Development Referral No. DN26/0002

Proposal: Request for response for the State Significant Development Application - Kamay Battery Energy Storage System

Property: 171-189 Captain Cook Drive, Kurnell

Image 1: Site Plan with annotations of setback distances to property boundaries (Source: Application Material)

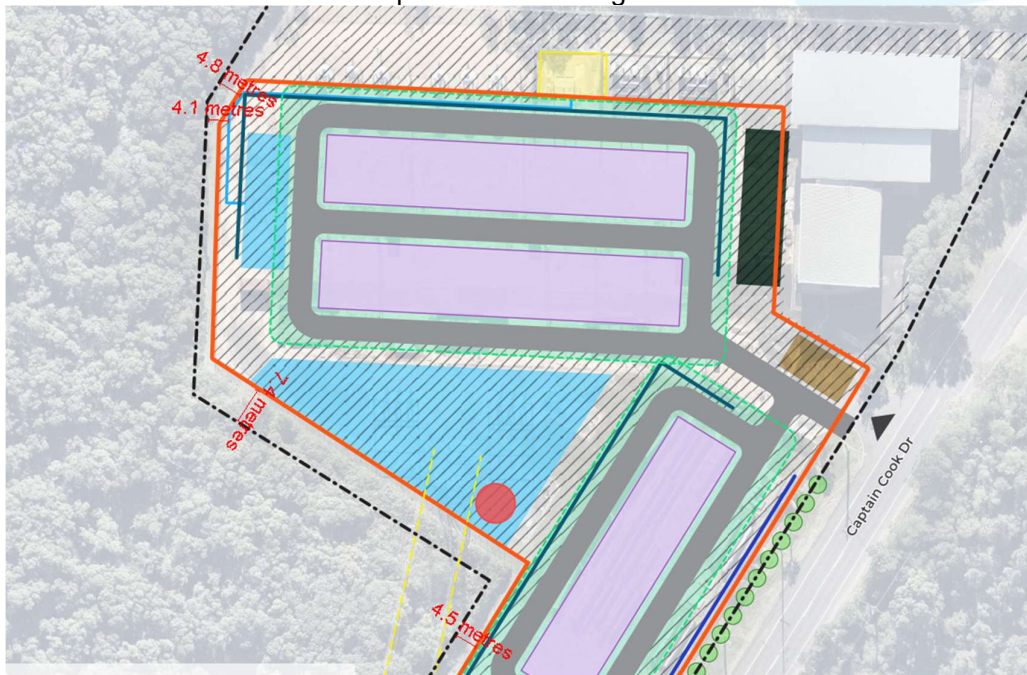
It is drawn to the Department’s attention that the Site Plan shows proposed landscaping along Captain Cook Drive is partly located within the road verge. This is not supported. The wall must be inset from the boundary so proposed landscaping is located wholly within the site boundaries.

On Page 17, Section 1, it is detailed that the BESS will be connected to the Kurnell Substation Infrastructure and this is represented by a light blue line on the Site Plan – refer to Image 1 below. The following mapping extracts (Images 2 and 3) show the mapped biodiversity values and wetlands. It has been calculated that the new connection will be through the environmentally sensitive land.

Of critical importance, the excavation and/or works to install this connection will further impact the environmentally sensitive land. On this basis, the application must be revised and detailed plans provided to show no intrusion into these areas, and in addition, including pre and proposed finished ground levels, batter height and width, drainage controls, foundation systems for the noise abatement walls and the like.

Image 4: Mapping extract showing the ancillary infrastructure area having setbacks less than 10m

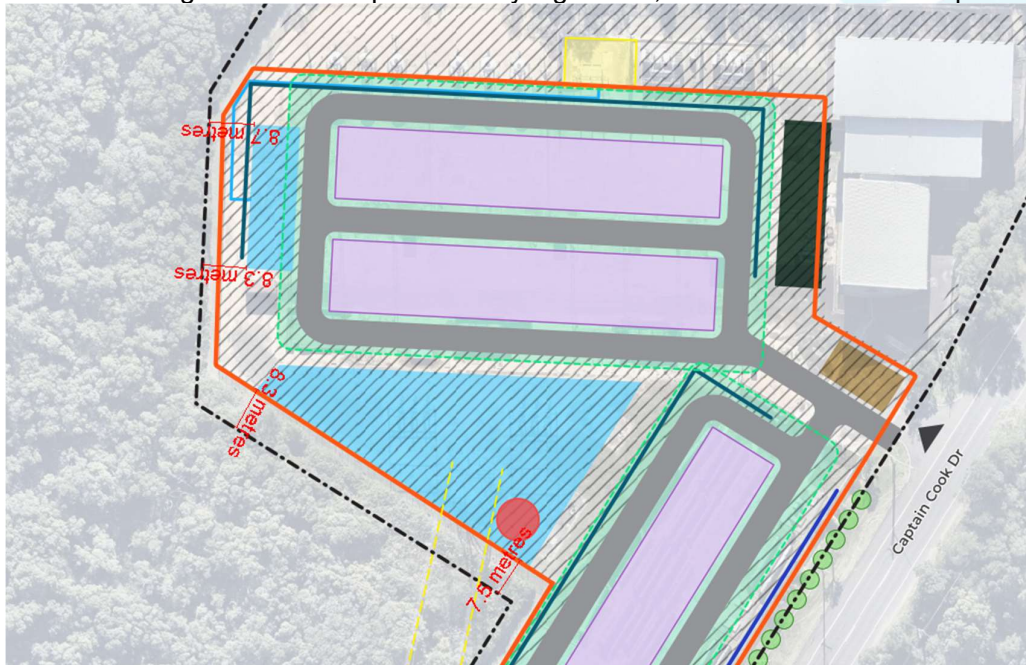
However, the site plan shows that the light blue area denoting the area to be used for 'ancillary development' has buffers/setbacks to vegetation that are less than 10m – refer to Image 4. It is acknowledged that a condition could be imposed to require a minimum 10m separation buffer, however, it is considered that the plans must be amended and the report revised to provide greater clarity and be representative of what is proposed.

Page 63 states that an APZ currently surrounds the site and management will continue without change. The proximity of the development to the environmentally sensitive land (i.e. less than 10m) raises issues. The application must be amended where the APZ buffer is established from the mapped biodiversity values and wetland areas, not the existing vegetative land. The seed bank of the vegetation is also protected by legislation, and this must not be impacted.
